CONNECTION ASSESSMENT & APPROVAL PROCESS

Preliminary Assessment Report For Caledonia TS

Applicant: Hydro One Networks Inc.

CAA ID 2002-056

Figure 3A: New Caledonia TS Autotransformers
Option A: 230kV Connection on N2M / N6M

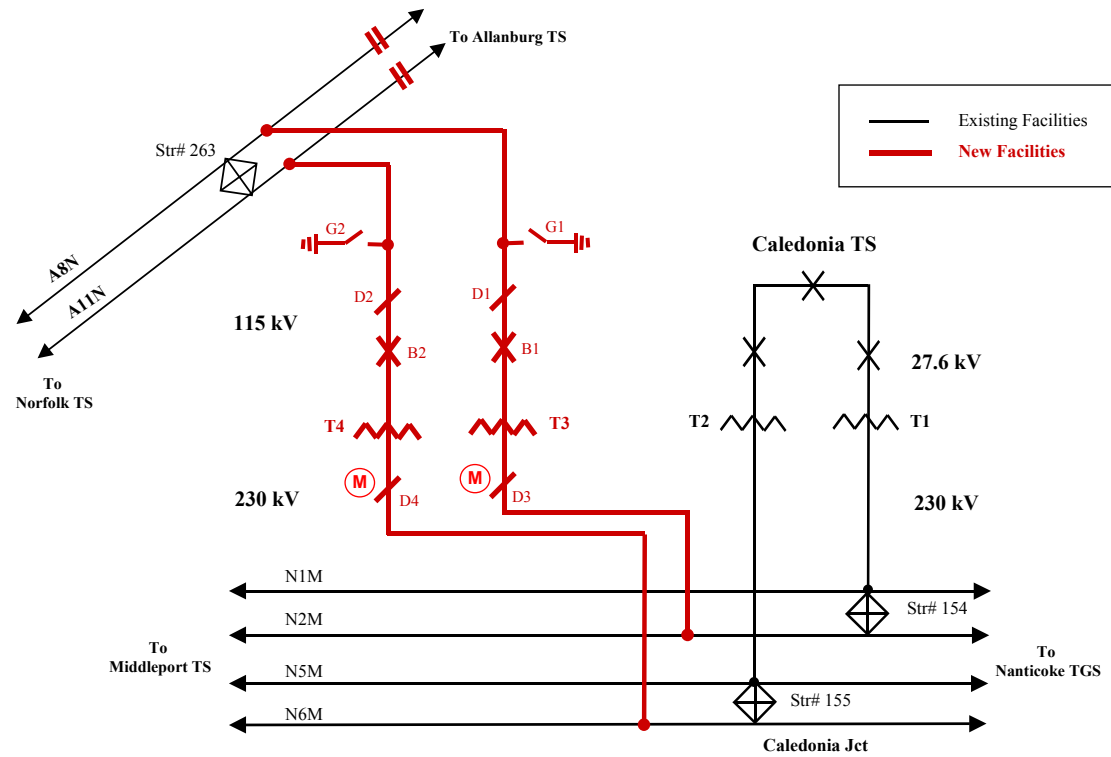
Option A, shown in Figure 3A proposes to connect the high voltage side of each new in-line auto-transformer to the 230 kV circuits N2M and N6M, respectively via a line drop of less than 50m.

Option A was found to be superior to option B because the clearing of a fault associated with one of the new transformers would not affect the supply of the existing Caledonia transformers. Also option A provides for a balanced distribution of the power flows on the 230 kV circuits from Nanticoke to Middleport because the existing Caledonia TS load and the Norfolk load would be supplied from different circuits.

It is required that Hydro One Networks Inc. implement the proposed option A for connecting the two new auto-transformers to the system. This arrangement connects the 230 kV side of the new autotransformers to N2M and N6M.

1. Hydro One Networks Inc. must implement the proposed option A for connecting the two new auto-transformers to the system, whereby the 230 kV sides of the new autotransformers are connected to N2M and N6M, respectively.
2. The low voltage shunt capacitor at Norfolk TS must be available for switching during periods of peak load conditions.
3. The new autotransformers be initially connected on the 116 kV off-load tap position or equivalent.
4. The status of all isolating disconnect switches and breakers must be monitored on a continual basis.
5. The proponent will provide when available, the "as built" transformer information to meet the requirements of the facility registration process.
6. The protection settings associated with the 115 kV circuits A8N and A11N and Norfolk TS must be reviewed and modified if needed, before the facilities are brought to service.
